Darlington Public School Redevelopment

State Significant Development Assessment (SSD-9914)

November 2020

Published by the NSW Department of Planning, Industry and Environment

Figure 17 | Construction vehicle routes and entrances (source: Applicant's EIS 2020)

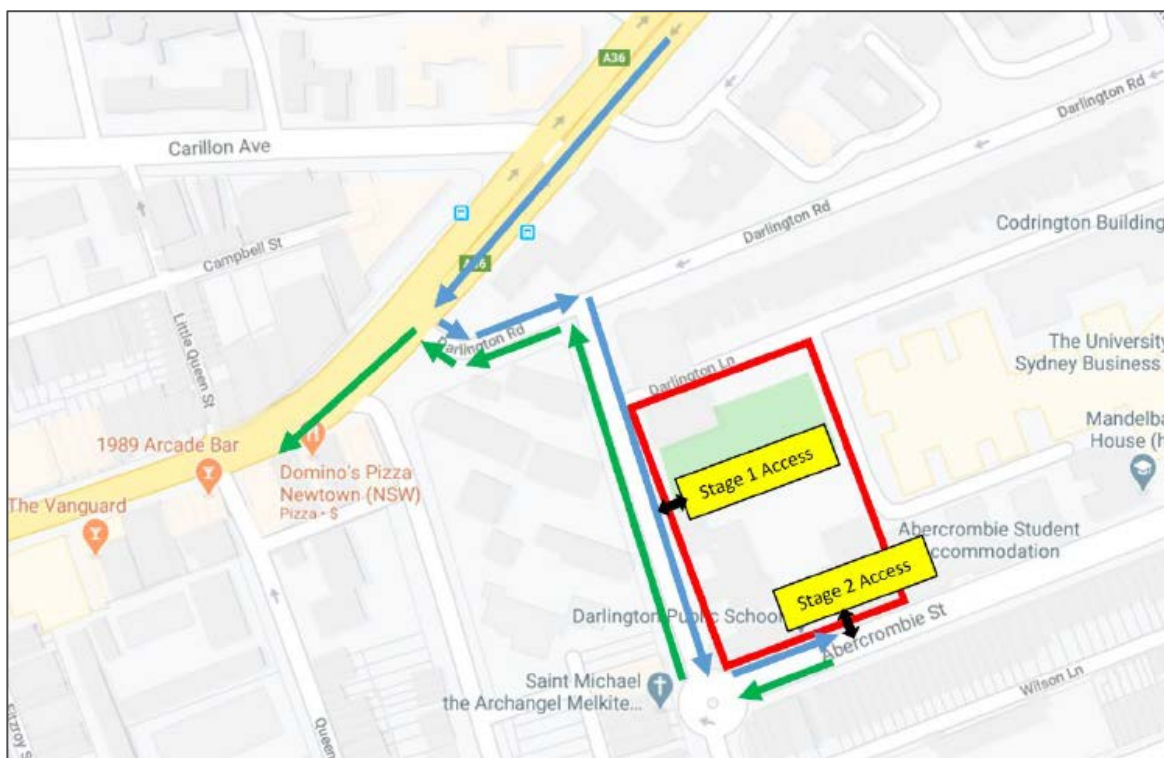
The Department has reviewed the PCMP and is satisfied that construction traffic would be appropriately managed during construction. As advised by TfNSW, a condition has been recommended to require the preparation of a detailed Construction Traffic and Pedestrian Management Plan in consultation with TfNSW and Council, that would finalise the proposed arrangements prior to commencement of construction.

Figure 18 | Site layout showing parking details for Golden Grove Street (Source: Applicant's EIS 2020)

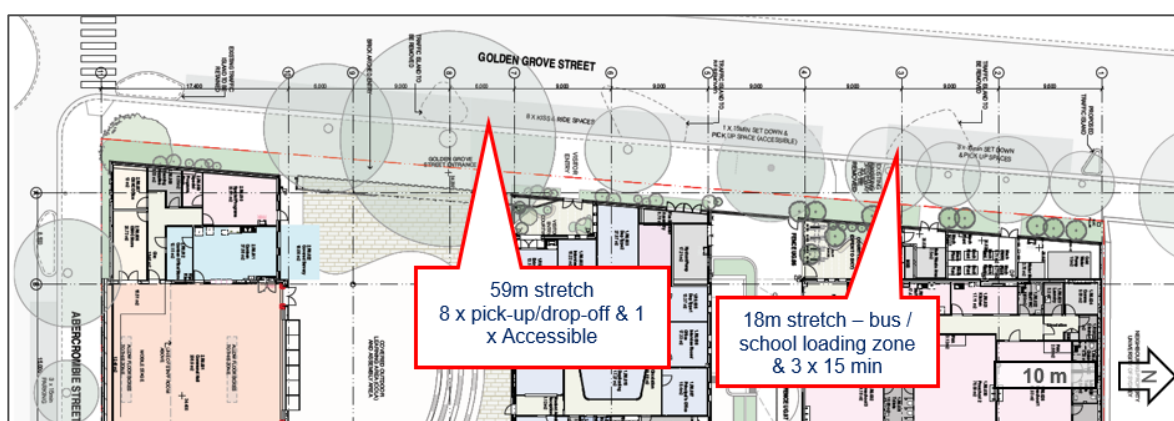
In its response to the RtS, Council raised concerns relating to:

The Department considers that the proposed car parking provisions would adequately and practicably service the needs of the school. The Department notes that any changes to parking restrictions or on street infrastructure is subject to Council approval. The Department has recommended a condition that the proposed changes be finalised in consultation with Council and be submitted to Council's Traffic Committee and Area Planning Manager for approval. It is considered that the above-mentioned issues raised by Council can be resolved at this time.

Figure 22 | Tree removal and retention plan (Source: Applicant's response to RFI #2, 2020)

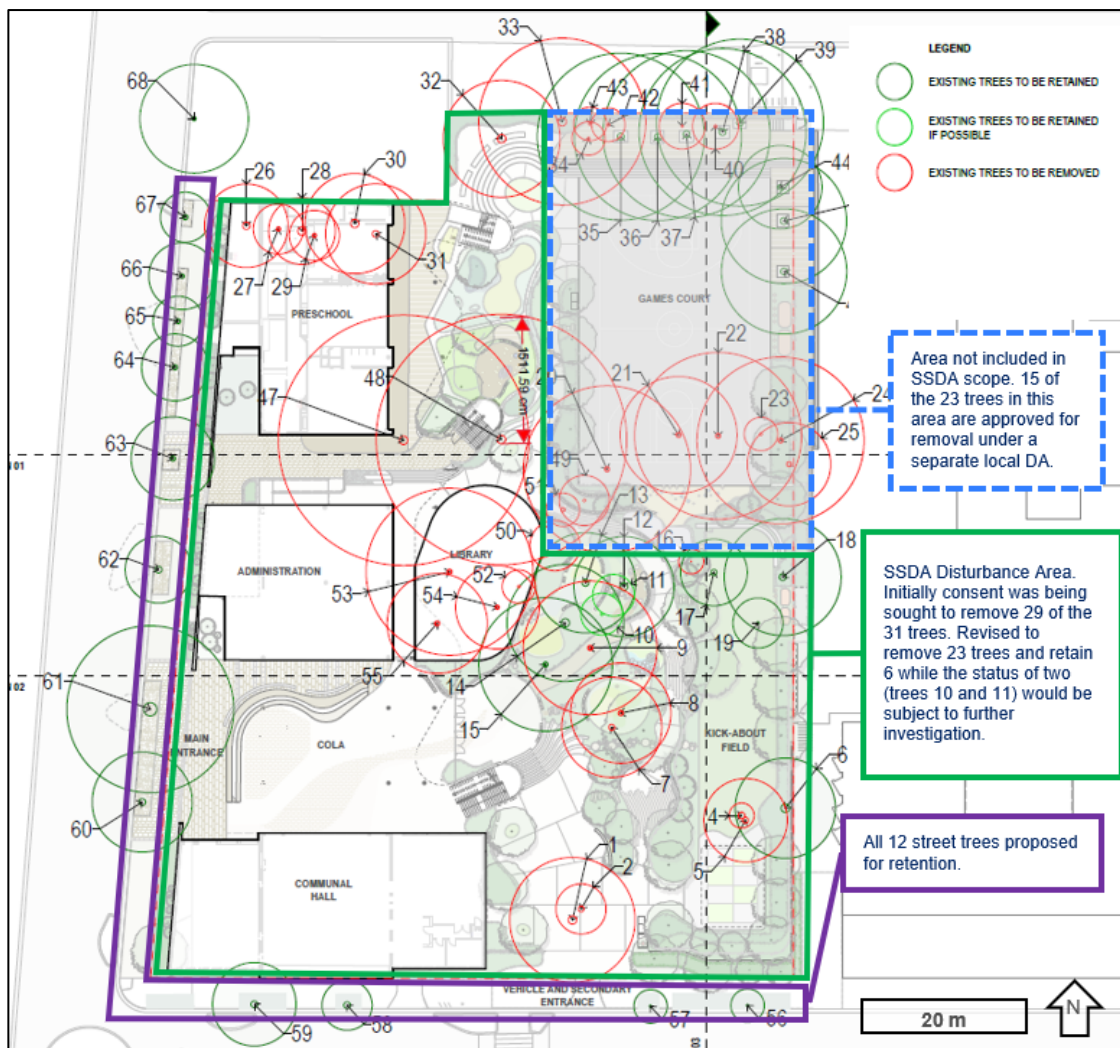
Initially, the SSD application sought permission to remove 29 of the 31 trees within the SSD project area. No justification was provided in the EIS or the accompanying arborist report for their removal. The extent of the proposed tree removal to accommodate playground areas was noted in the Statement of Heritage Impact, which found that this would have a visual impact on the surrounding heritage streets.

The Applicant's RtS did not include additional justification for the proposed tree removal or include the retention of additional trees on site. On 8 September 2020, the Department requested the Applicant provide additional information including justification for proposed tree removal and consider opportunities to retain additional trees.

The Applicant provided additional information on 22 September 2020, which was considered by the Department and referred to Council. It was considered by both the Department and Council that the justification lacked sufficient detail to warrant the removal of many of the trees, particularly those located outside the proposed building footprint. Council further stated that:

Council reviewed the additional information and stated that it was disappointed with the extent of tree removal still proposed. Council recommended conditions of consent to require:

The Department has assessed the additional information and Council's comments. It is considered that, in developing site layout options, insufficient weight has been given to tree retention. It is noted that, in discussing the masterplan options, the design report makes no reference to tree retention or loss. This has resulted in a site layout which requires the removal of the vast majority of significant trees to accommodate the built form, including a Sydney blue gum, a Spotted gum and a Tallowwood

The Department considers that the landscape plan amendments made by the Applicant in response to the Department's second request for further information are minor. The two additional trees proposed for retention do not address concerns about canopy loss due their small size. Further, several additional trees could be retained with some additional minor amendments to the proposed landscaping treatment.

- a tree retention study, which provided additional details to justify the removal of each tree.
- amended landscape plans which altered the proposed removal/retention status of eight trees:
 - tree 12 (River She-Oak) and trees 13-15 (Tallowwoods) changed from 'retain if possible, subject to further assessment' to 'retain'.
 - trees 17 and 19 (Illawarra Flame Tree and Bangalow Palm respectively) changed from 'remove' to 'retain'.
 - trees 10 and 11 (River She-Oaks) changed from 'remove' to 'retain if possible, subject to further assessment'.
- amended tree removal and retention plan to reflect the above changes (**Figure 22**).

Accordingly, the Department has recommended conditions that five additional trees be retained subject to further investigations to determine the measures required to retain the trees. To mitigate the extensive tree and canopy loss, replacement tree planting and landscaping is proposed on the site. The proposed landscape design seeks to create opportunities for learning spaces, outdoor rooms and areas of active, imaginative and quiet play through the use of connected paths and changing landforms (**Figure 8**).

- achieve a minimum 62% canopy cover across the site as proposed in the Applicant's RtS.
- include compensatory tree planting of at least 36 trees with 30% of the tree species having a mature height of at least 6m, 30% with mature heights of at least 10m and 40% mature heights of at least 20m, as recommended by Council.
- include native species appropriate to the Sydney region including at least one Sydney Blue Gum (*Eucalyptus saligna*) to replace tree 48.
- include mature plantings of specified pot sizes.
- provide sufficient soil depths to allow for plantings to reach maturity.
